The Great Grid Upgrade

Sea Link

Change Application Consultation Document

October 2025

Plate 4.7 Designated sites at the location of change 3

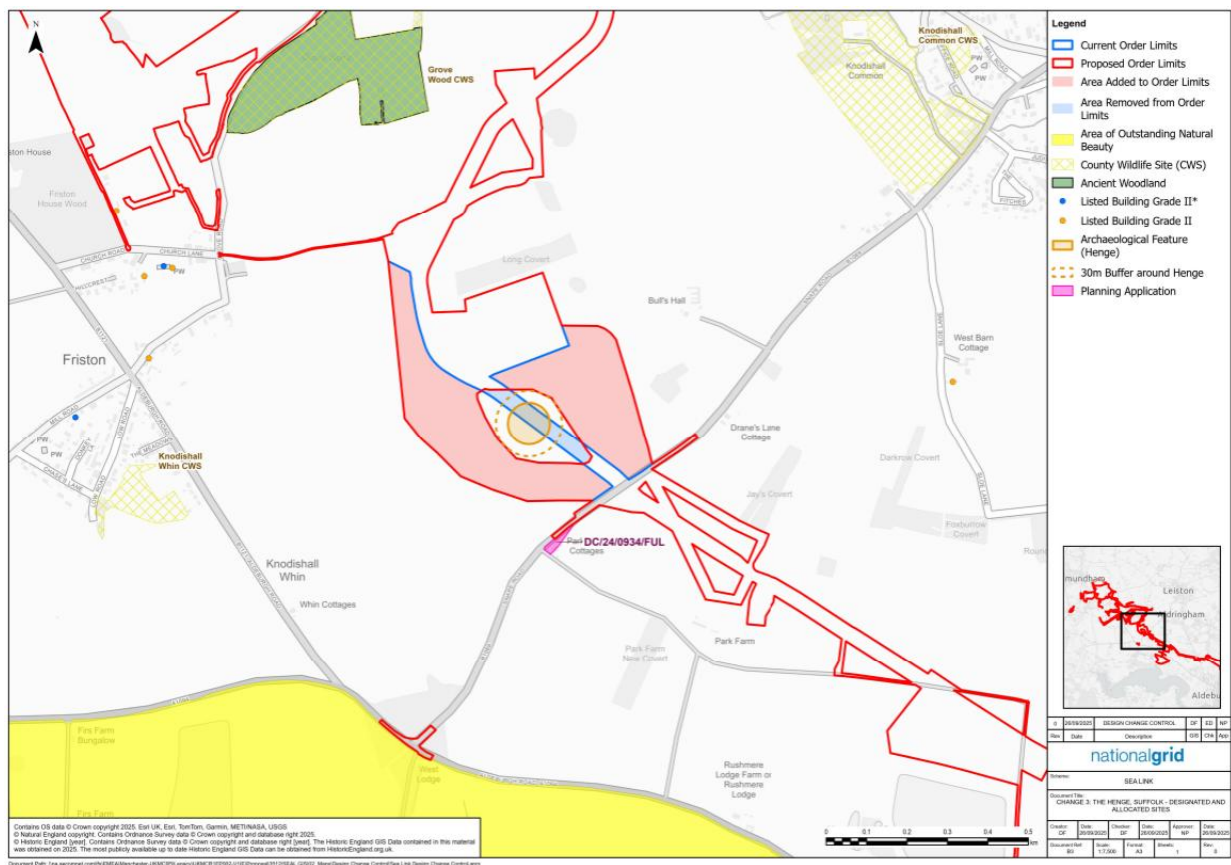
- 4.4.1 We are proposing to adjust the boundaries of the project so that a newly discovered heritage asset (a Neolithic Henge) is avoided by the project and protected. This means moving the planned underground cable route so it goes around the Neolithic Henge, with a 30-metre buffer zone to avoid the Neolithic Henge.
- 4.4.2 The proposed new boundary of our project that includes this change is shown below.

- 4.4.3 The henge was found during archaeological checks in July 2025, after our initial plans were submitted.
- 4.4.4 Instead of building over the henge, we propose to move the cable route to avoid it.
- 4.4.5 We looked at other ways (like drilling underneath the henge), but these could still risk damaging the henge, so were rejected.
- 4.4.6 Extra land will be included in our Order limits so we have flexibility in where to route the cable to either the north or the south of the henge, depending on the outcome of future detailed design. We would only exercise Compulsory Acquisition powers over the land required for the cable route, and not the full extent of the additional land.

Plate 4.9 Designated sites at the location of change 4

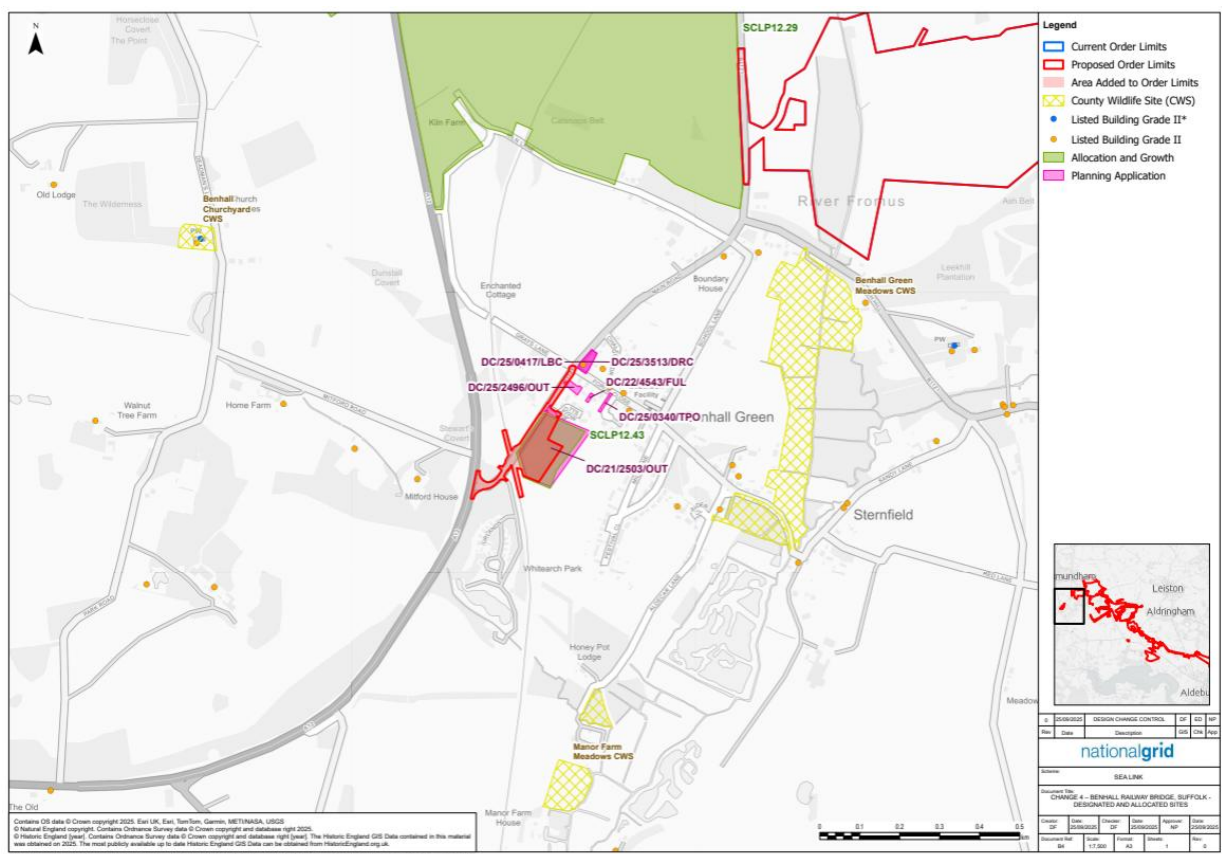
- 4.5.1 We propose adding additional land around Benhall Railway Bridge (on the B1121) into our Order limits. This includes land along the road, the bridge itself, nearby areas east of the bridge, and a small section along the railway. This change would provide additional flexibility when deciding how to transport large equipment to the new converter station.
- 4.5.2 The proposed new boundary of our project that includes this change is shown below.

- 4.5.3 The bridge has a weight limit (46 tonnes), which is fine for most construction vehicles, but would mean that the bridge may need strengthening to take some of the very heavy loads (like transformers and cranes) needed for the project.
- 4.5.4 Including the additional land would allow us to consider a wider range of possible ways of strengthening the bridge, when we come to reviewing this in detail during the construction phase. These could include ways that would need equipment temporarily storing next to the road. Including the road itself makes it clearer how we would organise and agree the roadworks with the highways authority.

- 4.5.6 Three main options for strengthening the bridge are being considered:
- Mini-bridge:
 - This would be a temporary bridge structure, installed as needed for heavy loads and then removed when not required.

Plate 4.10 Proposed new project boundary for change 5

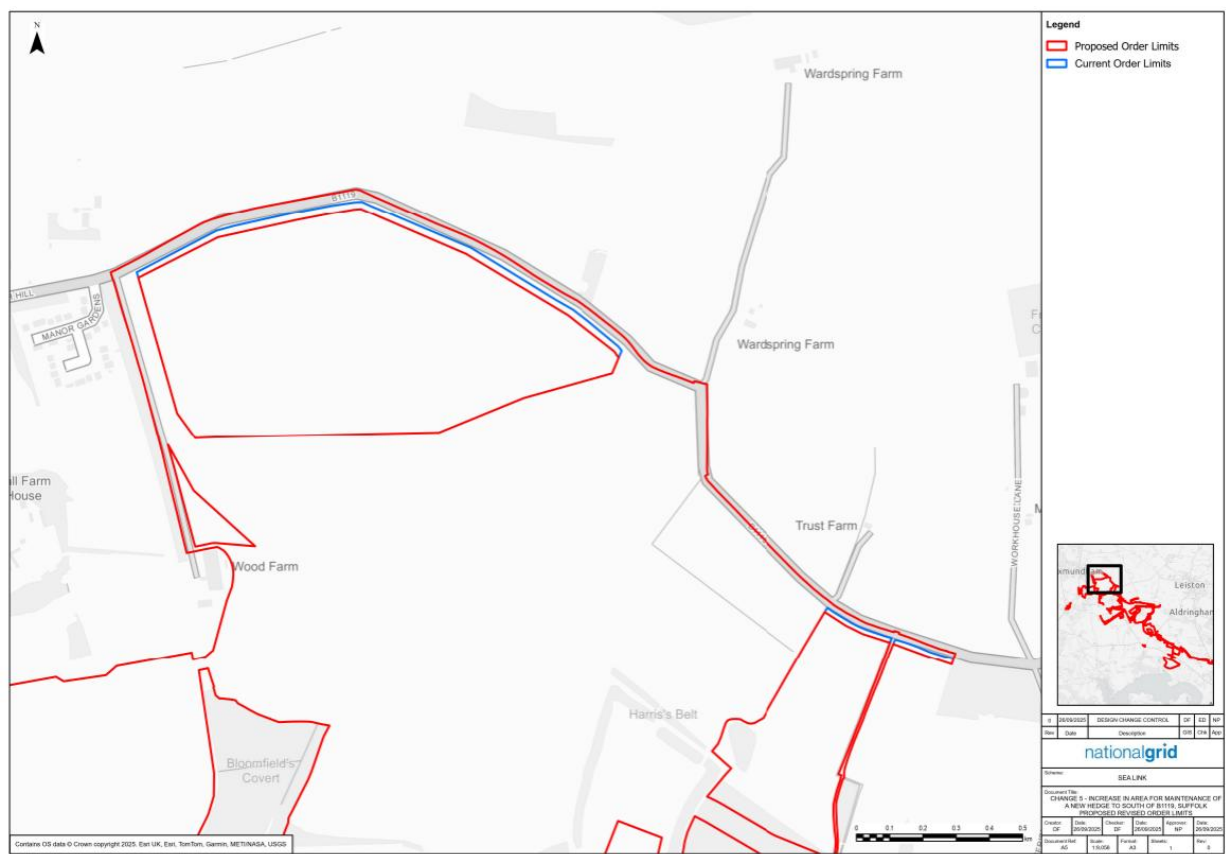
- 4.6.1 We want to widen the strip of land south of the B1119 (near Fristonmoor Lane in Suffolk) to give more space to plant the proposed new hedge and provide space to maintain the new hedge and the ditch. We also want to change the type of access rights to this strip of land to allow long term maintenance of the drain from the field.
- 4.6.2 The new hedge is an essential mitigation measure to reduce effects on the landscape and visual amenity and integrate the project into the existing landscape by screening views of the converter station from the north/north east and help to reinstate historic hedgerow planting. It will also help wildlife move between woodland and hedgerows/trees. The proposed new boundary of our project that includes this change is shown below.

- 4.6.3 The slightly wider strip of land would provide more space to maintain the existing ditch and the proposed hedgerow itself.

Plate 4.11 Designated sites at the location of change 5

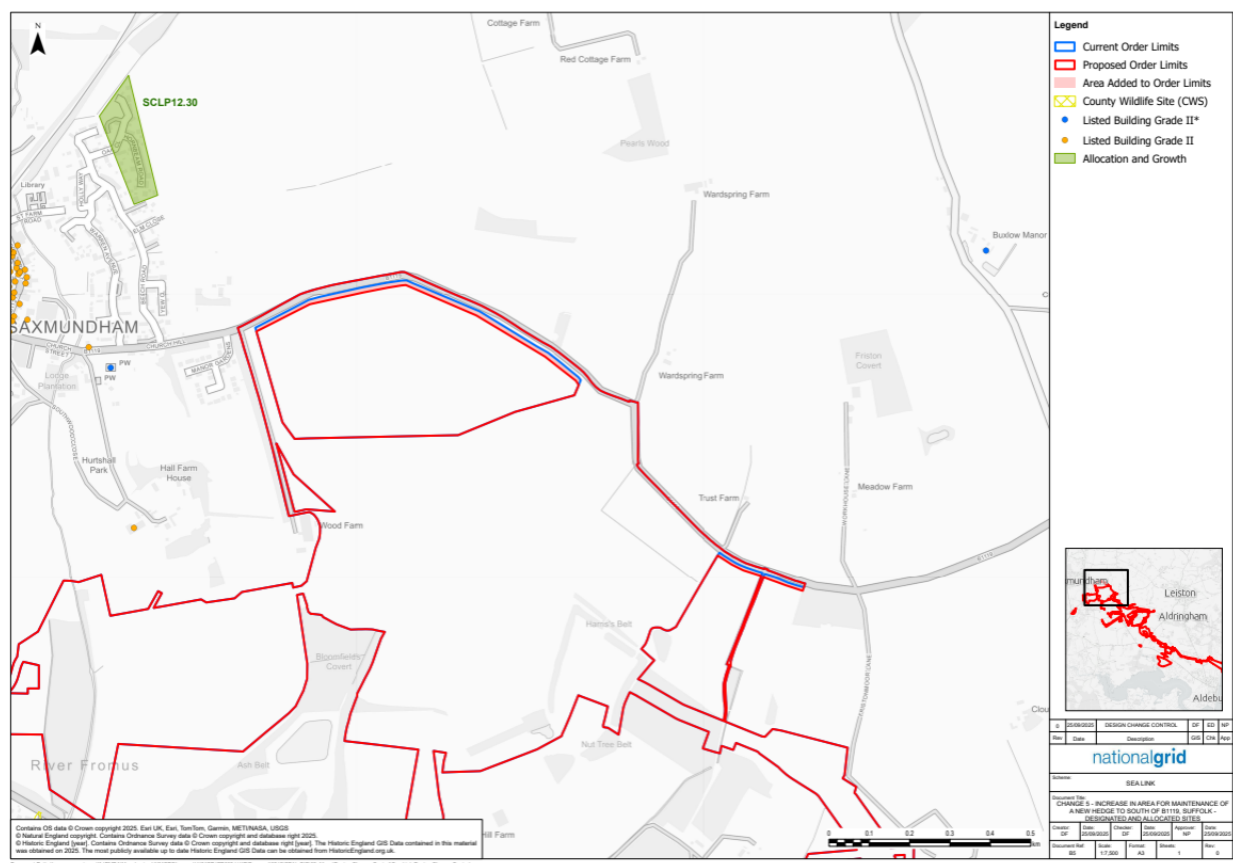
- 4.6.4 The change is considered to be minor and is unlikely to result in new or different significant environmental effects. The proposed change still includes the proposed hedgerow along the B1119, therefore retaining essential landscape mitigation for the project and making sure there is enough space to maintain this mitigation into the future. No new environmental receptors are likely to be adversely impacted as a result of the minor nature of this change. Further detail will be reported within the Change Application: Addendum to Volume 6 Environmental Statement.
- 4.6.5 The designated sites present within the vicinity of the proposed change are shown below.
